ENGINEERING EVIDENCE STATEMENT

SUNBURY SOUTH PSP &
35-60 FOX HOLLOW DRIVE, SUNBURY

PREPARED BY ANDREW MATHESON FOR
ASIA-PACIFIC PROPERTY GROUP PTY LTD
AUGUST 2017

Figure 2 – VPA Supplied Break of Slope and Areas of Interest

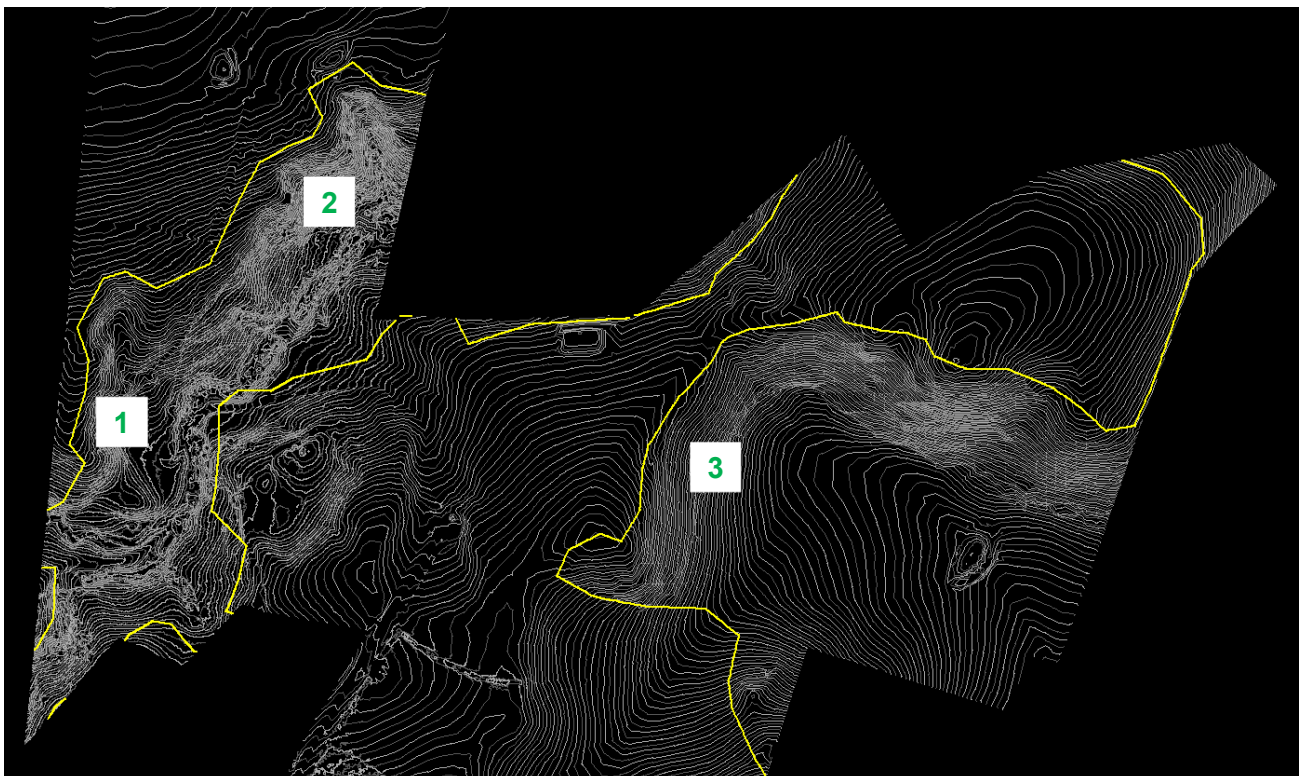
My analysis of the feature and level survey revealed the need to highlight several areas on the Subject Land which show no discernible break of slope adjacent to the VPA alignment. I have summarised these areas below and identified them in Figure 2 below.

Upon review of the feature and level survey plan, and analysis of the VPA provided Break of Slope, it is my opinion that the VPA Break of Slope line has been incorrectly located and that the Break of Slope location which I have identified, by scientific analysis, should be adopted.

- Review the Break of Slope line supplied by the VPA which has been incorrectly located and amend in accordance with Taylors scientifically assessed alignment.

Figure 3 – Area 1 Break of Slope Comparison

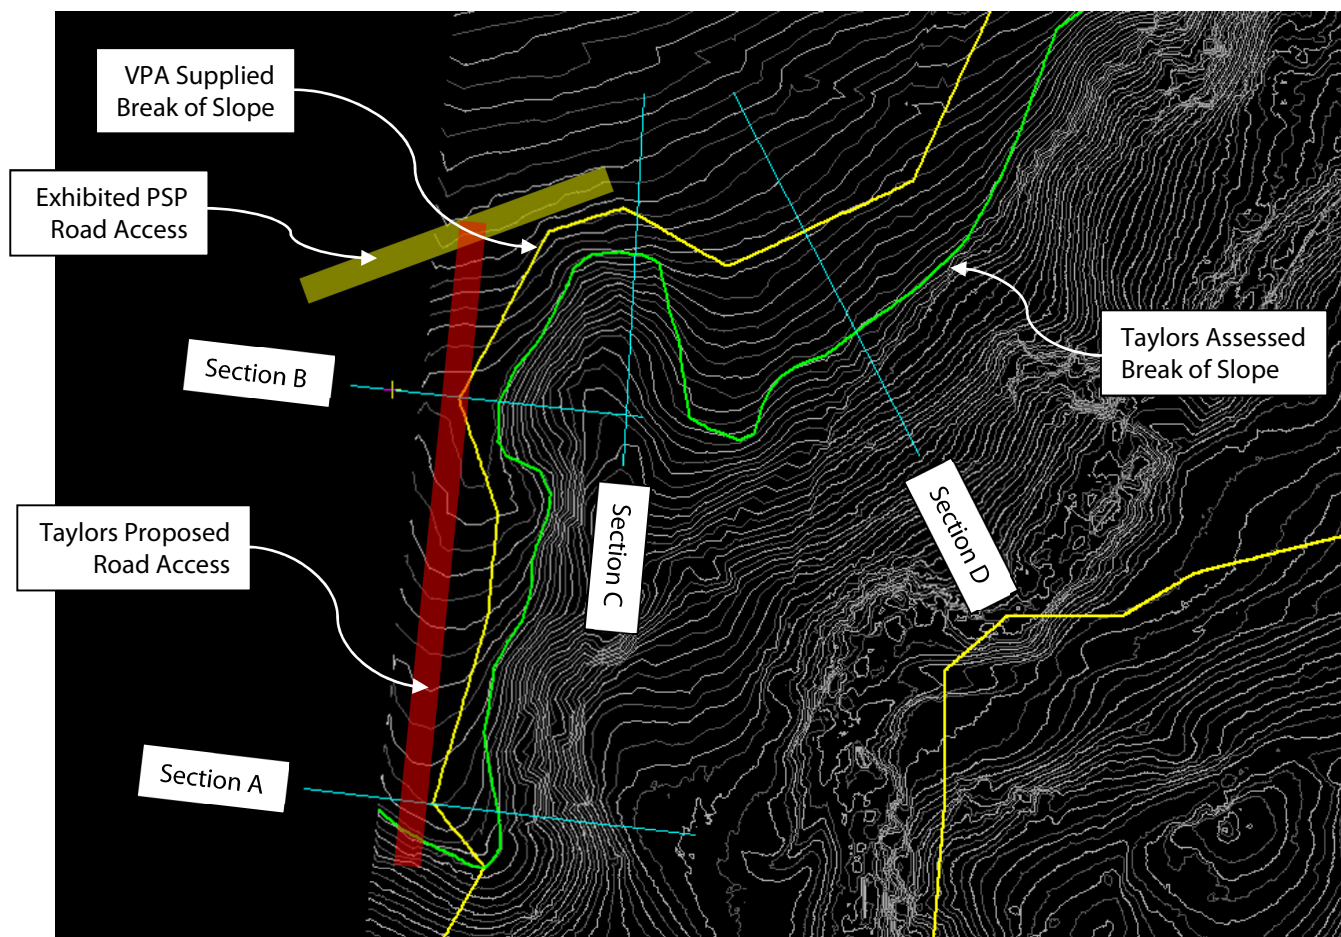
I have reviewed Area 1 and overlaid the VPA supplied Break of Slope alignment onto the Taylors feature and level survey using 12d® Model software; refer Figure 2 below. Taylors and Asia-Pacific Group see potential for a 16-metre-wide, Level 1 Access Street adjacent to the western boundary of the site with connectivity to the Connector Boulevard Road. This connection would eliminate the reliance on neighbouring properties for access to the northern developable areas of the Subject Land. The VPA break of slope line shows a minimum width of 11 metres between the site boundary and the break of slope. When compared to the feature survey, the minimum width is 24 metres to an actual significant change in gradient as can be seen by the contour information provided in Figure 2 below. It is my opinion, that on average, the VPA Break of Slope line has been inset approximately 10 metres too far into the developable area. Cross Sections shown in Figure 3 have been provided in Appendix B.

Figure 4 – Area 2 Break of Slope Comparison

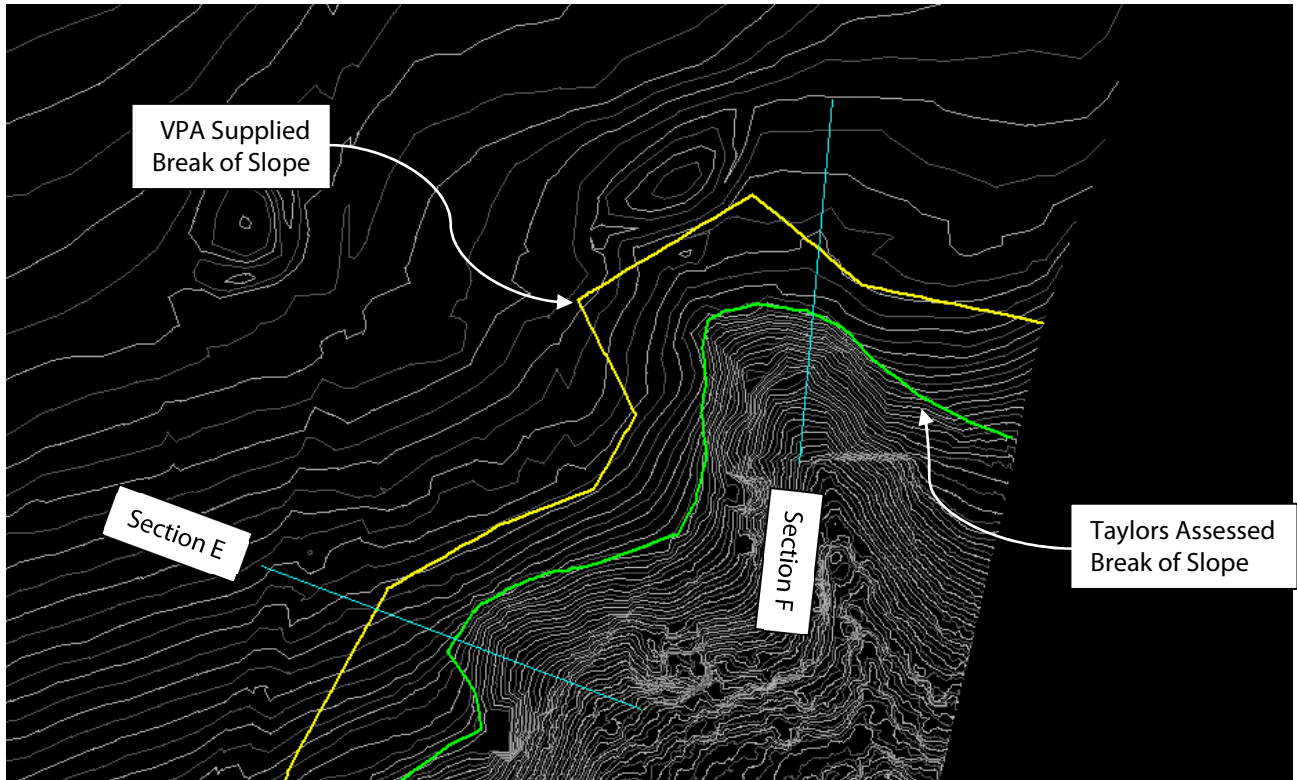
I have reviewed Area 2 and overlaid the VPA supplied Break of Slope alignment onto the Taylors feature and level survey using 12d® Model software; refer Figure 3 below. It is my opinion that, on average, the VPA Break of Slope line has been inset approximately 18m too far into developable land. Cross Sections shown in Figure 4 have been provided in Appendix B.

Figure 6 – Fox Hollow Drive / Connector Boulevard Intersection Grading

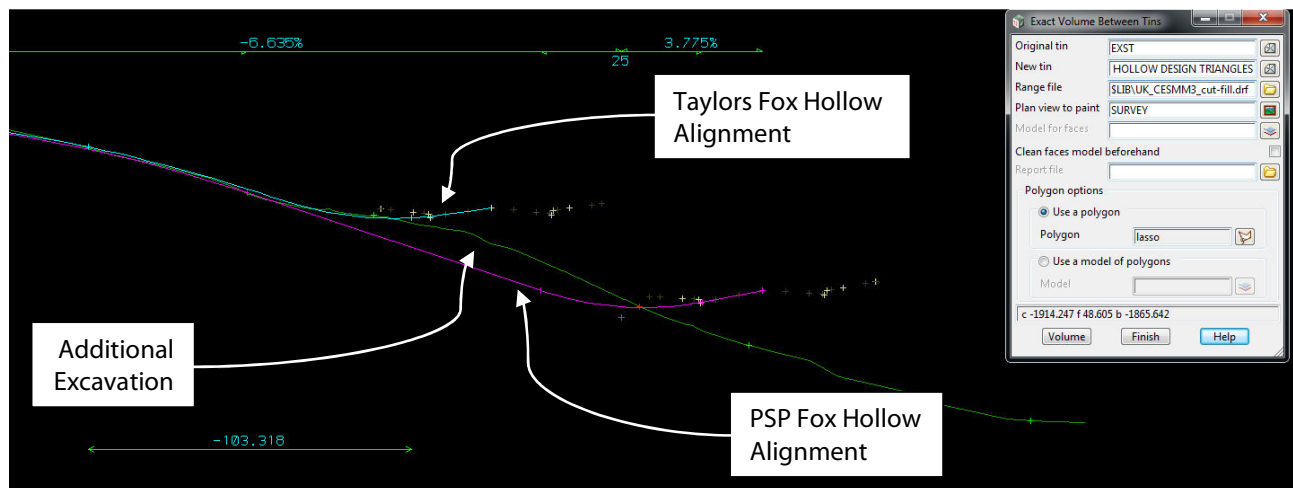
It is also my opinion that the intersection of the Connector Boulevard and Fox Hollow Drive as presented in the Asia-Pacific Group masterplan leads to better engineering outcomes. The revised Connector Boulevard design moves the alignment further south and onto an existing plateau that has been created for the existing court-bowl. By moving the intersection south to this plateau, the revised design eliminates approximately 41 lineal metres of road length, and also approximately 1,900 cubic metres of excavation that would be required to cut through the plateau; Refer Figure 6 below.

- Revise the alignment of the Sunbury Ring Road Southern Link (Connector Boulevard) and corresponding intersection with Fox Hollow Drive to reduce cost to the ICP and earthworks implications onto developable land.

Figure 7 – Earthworks Fill Batter Example

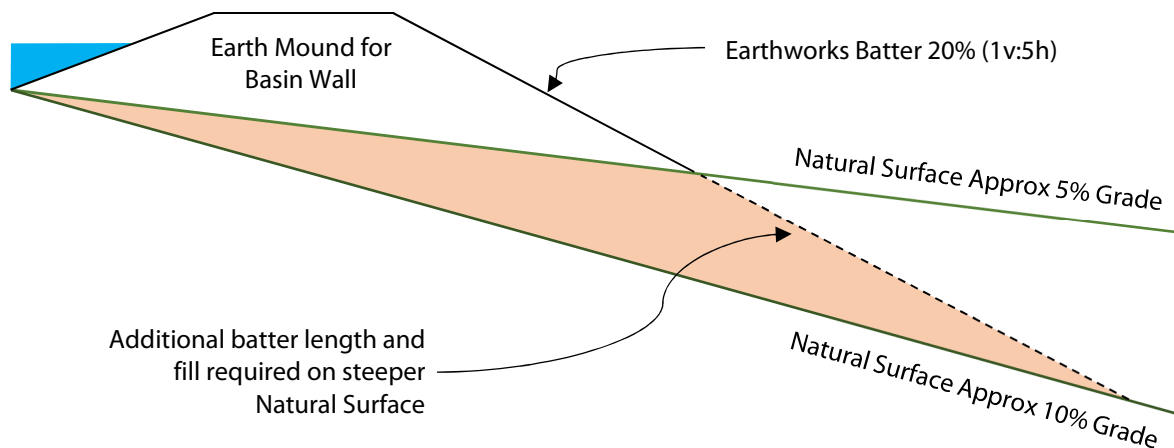
By relocating the wetland to flatter terrain, the overall size of the wetland can be reduced and earthworks minimised. A requirement of Melbourne Water is to achieve batter slopes no steeper than 1m vertical to every 5m horizontal (1v:5h) or 20% gradient. This results in improved safety and ability to maintain landscapes. The natural slope within the gully is on average 1v in 6h or a gradient of approximately 16.67%. A 1v:5h batter slope from a 1m high embankment or dam wall would require approximately 30 metres of horizontal distance before it intersects the 1v:6h gully slope. The land within the conservation zone has a flatter at a slope of 1v in 15h, or a gradient of approximately 6.67%. The same scenario of a 1m high embankment of dam wall would only take approximately 7.5 metres of horizontal distance before it intersects the 1v:15h terrain above the break of slope line.

This is a reduction of approximately 22.5 metres of batter length which when applied to the whole wetland would result in a large reduction of drainage reserve area. Figures 7 & 8 below show examples of fill and cut slope and the effect of steep terrain.

It is my opinion that by relocating WL-27 to the flatter terrain within the conservation zone, a significant reduction in drainage reserve size and earthworks disturbance to the natural terrain can be achieved. The comparison design that I have prepared to test these assumptions is provided in Appendix B. The re-design of WL-27 has resulted in an overall Wetland reserve size of 0.95 hectares; a reduction of 1.96 hectares. This is a catchment-to-wetland ratio of 7.9%.
